UNITED STATES PATENT AND TRADEMARK OFFICE

APPLICATION NO.	FILING DATE	FIRST NAMED INVENTOR	ATTORNEY DOCKET NO.	CONFIRMATION NO.
10/735,783	12/16/2003	Hsia-Hui Chen	MR1197-598	4117

Office Action Summary	Application No. 10/735,783	Applicant(s) CHEN, HSIA-HUI	
	Examiner Winnie Yip	Art Unit 3636

Part II DETAILED ACTION

FIG. 3

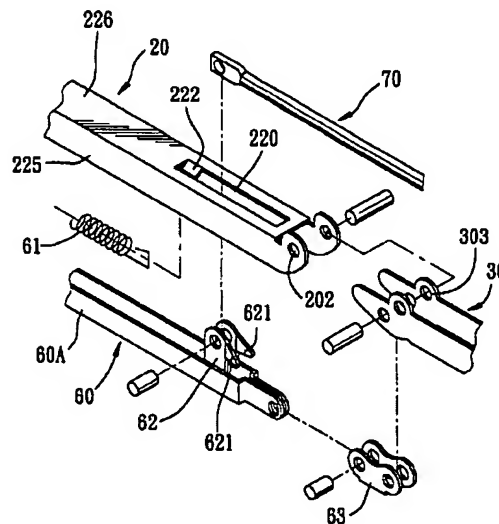
Wang teaches a multiple-fold umbrella comprising a plurality of ribs, each rib having a multiple pivotally joined rib sections (i.e., 30, 20), a joint being pivotally coupled between two rib sections, the joint having a wide base (63) and pins (P1, P2, P3), the joint being pivotally coupled to one rib section (30) by two pins (P1, P2) (see illustration bellow), one of the two pins (P2) being pivotally coupled to another rib section (20), the two pivotally coupled rib sections being positioned, counted from outside, in side by side relationship within the base of the joint in collision (see Fig. 6).
